Subject: Comanche Peak Steam Electric Station Independent Assessment Program -  
Response to CASE Questions

Reference: (1) Brief Summary of Generic Problems from CASE Witness Jack Doyle,  
2/22/84.  
(2) Brief Summary of Cross-examination Questions from CASE Witness  
Mark Walsh, 2/22/84.

Comanche Peak ASLB Hearings  
Response to CASE Questions  
Question No.: Walsh #8  
Exhibit No.: None

- o As-Built Re-Verification Form 1267

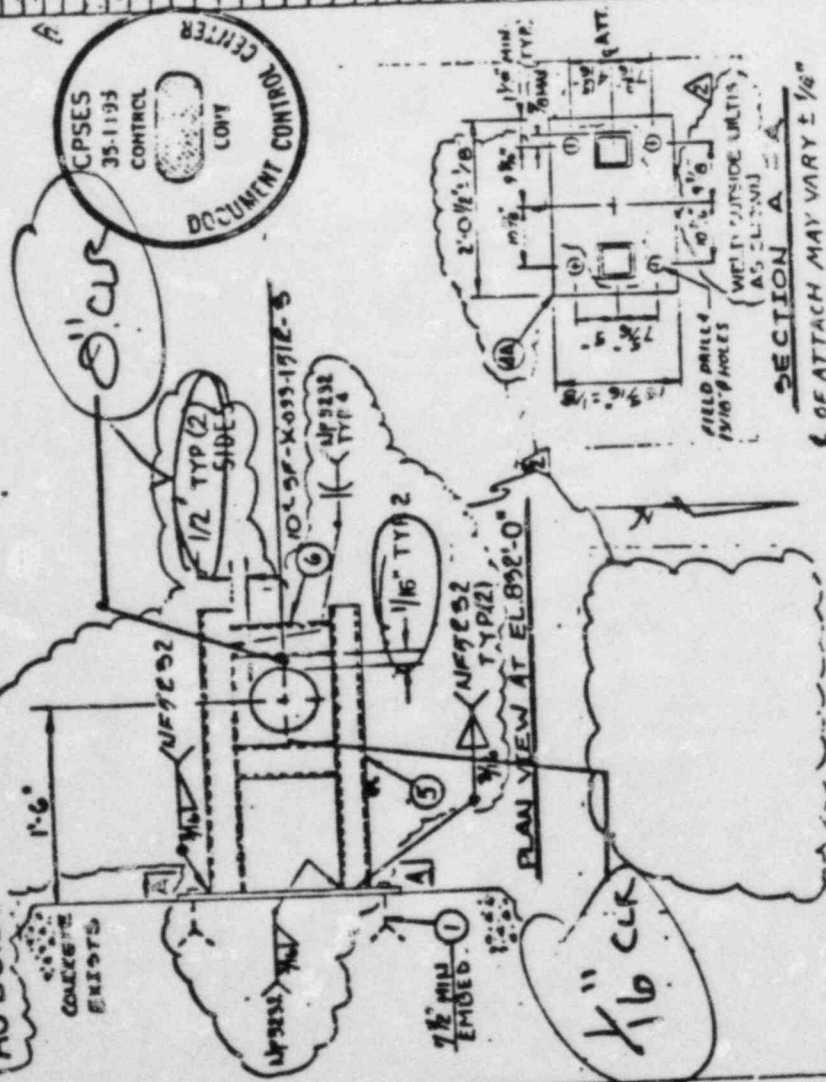
WD-03-01. What documentation was there that "accept as is" was valid? Were there calculations to support this?

How was the adequacy of the "accept as is" approval verified?

Cygna resolved this observation by reviewing the CPSES field inspection documentation. The key documents addressing Observation WD-03-01 are described below and attached for your information:

This document shows that the gaps were identified during an inspection and design review.

This document shows the clearances measured by the as-built inspector.

Project	TEXAS UTILITIES - CPSEB	Prepared By	<i>[Signature]</i>	Date	28 Feb 94
Subject	BASE PLATE FLEXIBILITY / ANCHOR BOLTS	Checked By	T. Witting	Date	3/13/84
System	DETAILS A, B, C, D, DRWG 2323-E1-601-S	Job No	84042	File No	
Analysis No	N/A	Rev No	0	Sheet No	1/

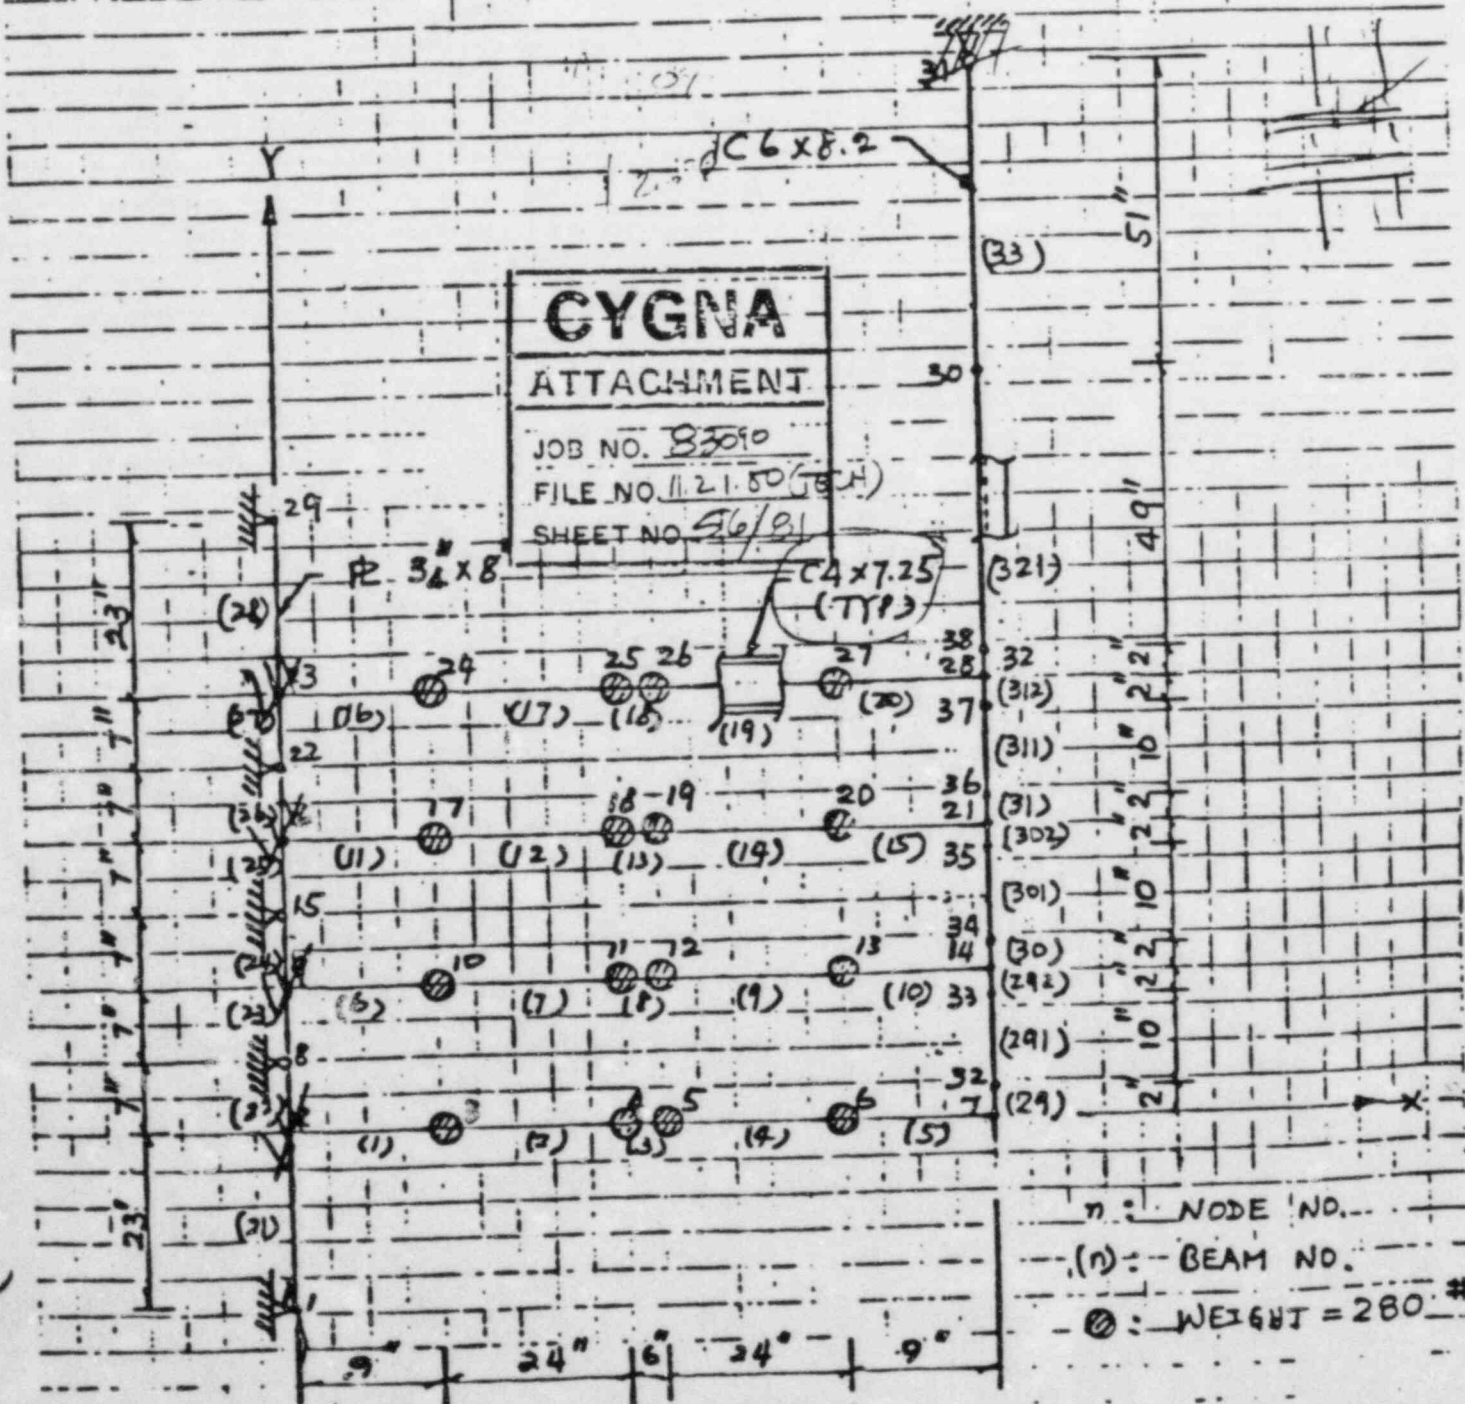
Cable Tray Checklist: CTS-II, Item 6, problem 4. This was not discussed in CTS-00-07.

"The interaction equation is employed using the tensile bolt forces from the horizontal tray loads. All other tensile components are ignored. The tensile and shear ratio is also reduced by a ratio of vertical and horizontal spectral values. No reason is given for this reduction. Without the reduction, the anchor bolts would fail. See Observation No. CTS-00-07."

How was this question on anchor bolt loads addressed in Observation CTS-00-07?

QUESTION B BY MR. MARK WALSH IS CONCERNED WITH THE REANALYSIS OF THE BASEPLATE FOR DETAILS A, B, C, D OF DRWG. 2323-E1-601-S AS DISCUSSED IN OBSERVATION CTS-00-07.

THE ANALYSIS IN QUESTION IS LISTED IN TECH FILE 11.2.1.50 PAGES 56-58. THE ANALYSIS IS CONSERVATIVE FOR THE PLATE STRESS.

TO CHECK THE BOLTS, CYGNA RAN AN ANALYSIS FOR THE MODEL SHOWN ON P. 56 OF THE TECH FILE WITH JOINTS AT THE BASE PLATE AND THE HANGER JOINT FIVE. THE FIXED END LOADS WERE APPLIED TO A BASE PLATE MODEL. THE PROGRAM PSDS WAS USED IN THE ANALYSIS.

BOLT	INTERACTION RATIO	
1	.115	} OK
2	.730	
3	.052	
4	.451	
5	.659
